**PLANNING CLEARANCE**  
(Single Family Residential and Accessory Structures)  
Grand Junction Community Development Department

BLDG ADDRESS 426 Prospector's Point TAX SCHEDULE NO. 2945-174-34028  
 SUBDIVISION The Ridges SQ. FT. OF PROPOSED BLDG(S)/ADDITION 1282  
 FILING Six BLK Nine LOT 28 A SQ. FT. OF EXISTING BLDG(S) \_\_\_\_\_  
 (1) OWNER Steve Alamos NO. OF DWELLING UNITS  
 BEFORE: 0 AFTER: 1 THIS CONSTRUCTION  
 (1) ADDRESS 426 Pros. Pt. NO. OF BLDGS ON PARCEL  
 BEFORE: 0 AFTER: 1 THIS CONSTRUCTION  
 (2) APPLICANT Lee Garrett USE OF EXISTING BLDGS N-A  
 (2) ADDRESS 2386 West Plateau Ct. DESCRIPTION OF WORK AND INTENDED USE: New  
 (2) TELEPHONE 243-0572 House (Single Family Res.) Construction

**► APPROVAL FOR BUILDING PERMIT ◀**  
**Ridges Architectural Control Committee (ACCO)**

426 Prospector's Point

Plot Plan

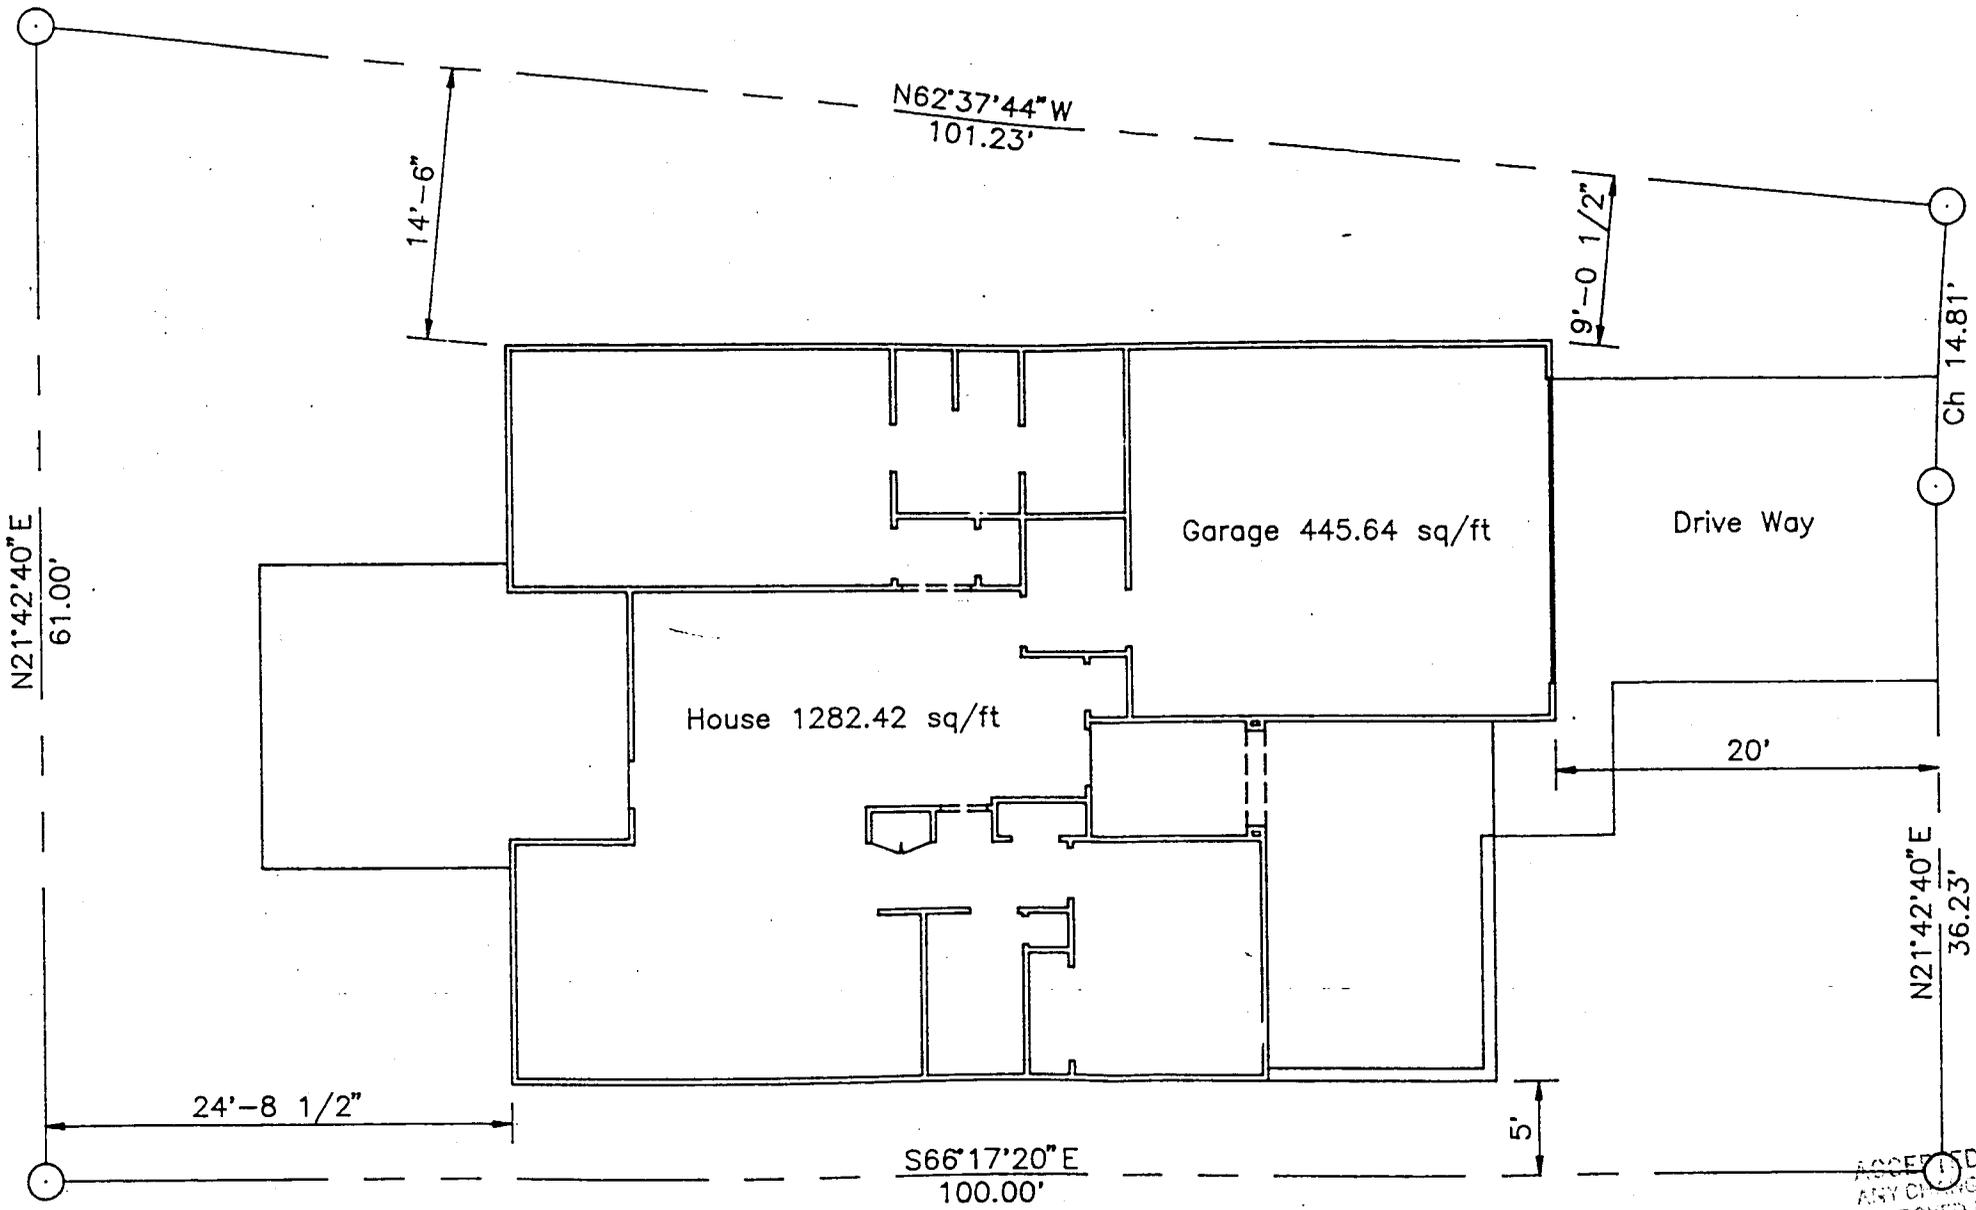
| <input checked="" type="checkbox"/> | <input type="checkbox"/> | Front setback (20'-0" minimum) <u>20'</u>                            |
| <input checked="" type="checkbox"/> | <input type="checkbox"/> | Rear setback (10'-0" minimum) <u>24'</u>                             |
| <input checked="" type="checkbox"/> | <input type="checkbox"/> | Side setbacks (10'-0" minimum "B" and "C" lots) <u>5' and 9 1/2'</u> |
| <input checked="" type="checkbox"/> | <input type="checkbox"/> | Drainage <u>natural front-eastward rear-westward</u>                 |
